ADDENDUM NO. 8
July 29, 2019

PARKING STRUCTURE 1
PROJECT NO. 956553

Water Facility Map

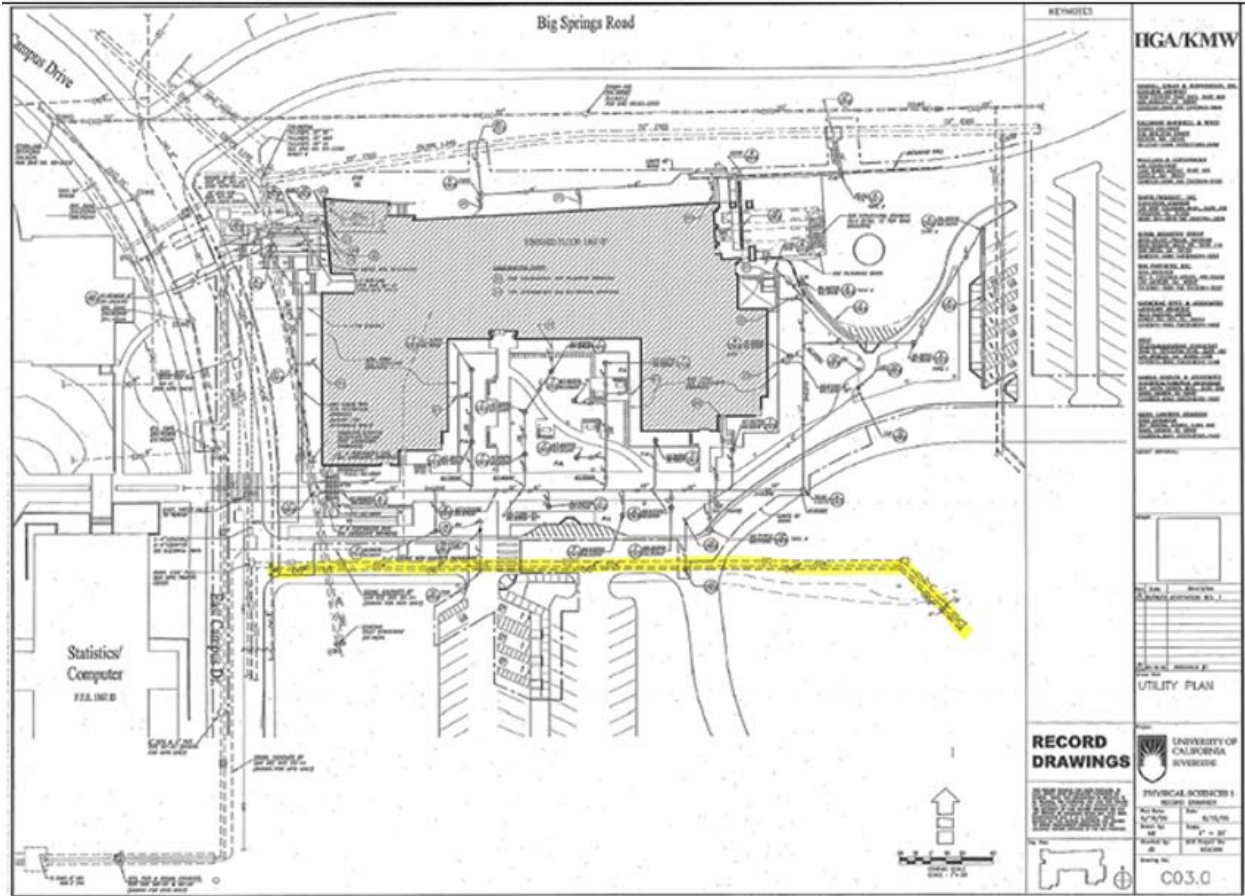
A36	Point of connection is MH16. See exhibit provided as University Furnished Information, Item 2G “As Builts – Power & Data Points of Connection”, which is incorporated herein by this Addendum.
Q42	<u>Water Facility Map</u> . The RFP includes two sets of fire hydrant flow data. One at a hydrant located north of Big Springs Road and one to the south of the project site at the Salinity

Laboratory. We are requesting a copy of a water facility map that shows the size and location of the water mains that serve the hydrants and nearby buildings. This will allow us to more efficiently design the water system required to provide fire protection to the proposed parking structure.
A42	A complete Water Facility Map is not available for Lot 13 and the immediate surrounding area. See attached additional University Furnished Information, Item 2F “As Builts – Water Facility Map”, which is incorporated herein by this Addendum. All information provided herein to be verified by the Design Build Team.
Q49	Please see below question regarding anticipated fees: 1. Will UCR be charging for utility consumption usage (ie. Power, water, etc)? If so, what rate will the costs be assessed? 2. Are the building permit fees covered by UCR? If no, please advise anticipated costs for this item.
A49	1. There will be recharge for utility usage. The utility rates charged to the Design Build Team will be consistent with the current local rates of the jobsite at the date of use. 2. No; the Design Build Team shall cover all city permit fees and submit fee expenses to the University for reimbursement. There will be no permit fees for construction on University property.

Power & Data Points of Connection

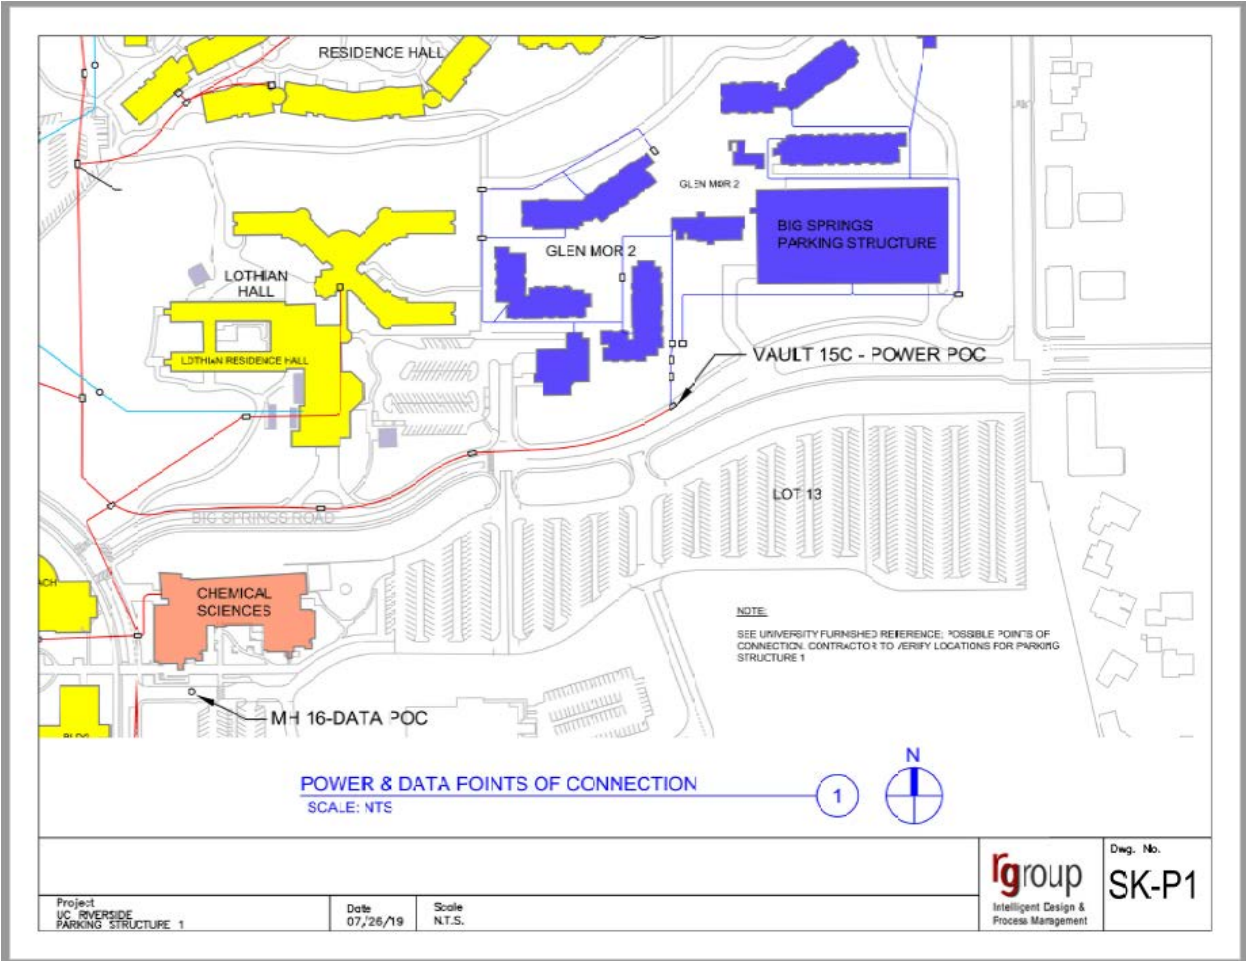
Q33	Where is the point of connection to the Campus 12kv system that we are to use for this project?
A33	The point of connection is “Vault 15-C”. See exhibit provided as University Furnished Information, Item 2G “As Builts – Power & Data Points of Connection”, which is incorporated herein by this Addendum.
Q35	The Basis of Design states “PS1 entry to MDF should consist of two (2) distinct conduit entries originating from opposite sides or corners of the Parking Structure 1 to provide redundancy/flexibility in the event of natural disaster or planned construction. Provide (3) 4” conduit penetrations through the floor for future”. Does this mean two separate services of (3) 4” conduits to the MDF from the Campus existing underground telephone system? If so, please provide the point of connection(s) to be used.
A35	See response to Q36.
Q36	If only (1) service to the MDF is required, please provide the point of connection to be used and confirm the quantity and size of the service conduits.

Q51	Please provide the electrical power and communication As-Builts as we currently cannot locate the points of connections for these services to the parking structure. The file under the <i>University Furnished Info>2. As-Builts folder, B. Glen Mor 2 Electrical Dist. Ext.-Fiber 2013</i> , appears to only show stormwater BMP’s, no electrical or communications.
A51	See response to Q33.
Q52	BOD page 28 Landscape Criteria calls for us to include 1 tree for every 8 uncovered parking spots in Lot 13. The City of Riverside calls for 1 tree for every 4 uncovered parking spots. Please clarify.
A52	Provide per Basis of Design.
Q53	BOD page 40 calls for Pervious Concrete Paving in accordance per the UCR provided geotechnical report. Soils Report page 7 Pavement Sections calls for normal asphaltic concrete paving. Please clarify.
A53	Pervious Concrete Paving is not required.
Q54	The Design criteria notes there are supposed to be 3 Entry and 3 Exit lanes at the main entrance to the parking building. The plans provided in the RFP show a total of 4 entry and 4 exit lanes at three locations and only 2 at the main entry. Please verify that the minimum 3 entry and 3 exit lanes can be divided at two entrances similar to the RFP drawings provided and not one. Clarification only.
